Product Change Notification / SYST-07KIRV017

ERRATA - PIC32MK General Purpose and Motor Control (GP/MC) Family Silicon Errata and Data Sheet Clarification Errata Document Revision

Description of Change: • 59. (Flash - RTSP)

PIC32MK General Purpose and Motor Control (GP/MC) Silicon Errata and Data Sheet Clarification

FIGURE 1: POSC CRYSTAL CIRCUIT

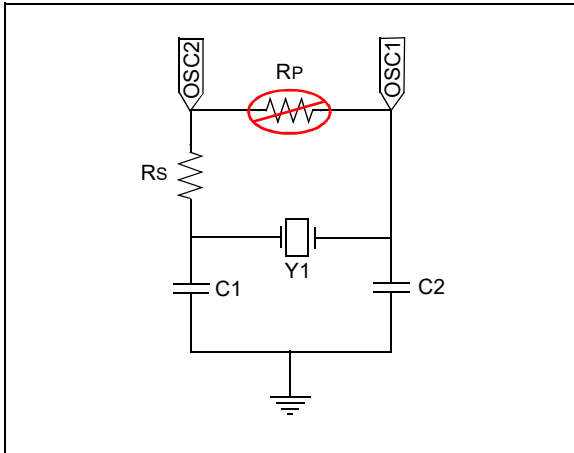
1. Module: Primary Oscillator

The POSC supports only specific crystal operation, as provided in [Table 1](#).

The Primary Oscillator (POSC) has been characterized to operate at 8 MHz and 12 MHz when the circuit shown in [Figure 1](#) is implemented and the operating conditions provided in [Table 1](#) are met.

Crystal Frequency (see Note 1)	Series Resistor Rs	POSC Gain Setting POSCGAIN<1:0> (DEVCFG0<20:19>)	POSC Boost Setting POSCBOOST (DEVCFG0<21>)
8 MHz	2 kΩ	'0b00 (GAIN_0)	'0b1
12 MHz	1 kΩ	'0b00 (GAIN_0)	'0b1
24 MHz ⁽³⁾	0	'0b00 (GAIN_0)	'0b1

- Note 1:** Using any other crystal frequency will require special component selection and characterization.
- 2:** A parallel resistor (Rp) should not be used to increase the gain of the POSC.
- 3:** Only 24 MHz crystals with a Mfg ESR ≤ 40Ω.

FIGURE 2: RESET SUPERVISOR CIRCUIT

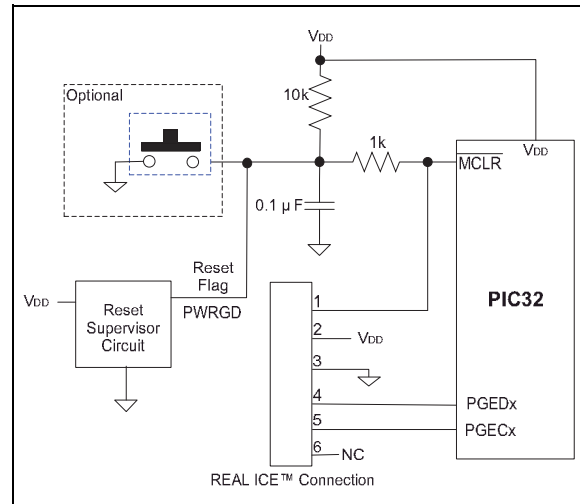
53. Module: BOR

On a BOR event, $V_{POR} < V_{DD} < V_{BOR}$, a Reset is not generated when the BOR threshold is reached. System clocks will stop with all I/O pins functions frozen in their present state until either V_{DD} falls to V_{POR} or V_{DD} returns to above V_{BOR} . The user must assess if this V_{DD} brown-out condition and the resulting frozen I/O pin state has an adverse effect on their application (UART, PWM, I/O, OC, etc.).

Use an external Reset supervisor/monitor (see Figure 2). Some LDO regulators, as listed in Table 4, have an embedded reset supervisor included. The required minimum reset trip voltage of the supervisor should be at least $(V_{BOR} + 0.5V)$ with the SMCLR bit (DEVCFG0<15>) = 0 and the BORSEL bit (DEVCFG2<29>) = 1 in the Configuration Words. This means that the minimum V_{DD} operating voltage of the application needs to be above the reset supervisor maximum trip voltage at [Reset Trip (max) + 0.2V], (i.e. Application $V_{DD(MIN)} = \sim(V_{BOR} + 0.5V + 0.2V)$). The reset supervisor should have an open drain output so as not to interfere with the MPLAB

programming/debug tools. This workaround assures that MCLR will generate an internal POR and reset the I/O pins before the V_{BOR} trip point.

Part Number	Reset Trip	CPU MCLR Source
MIC803-26D2VC3	2.63v	Reset pin (Open Drain)
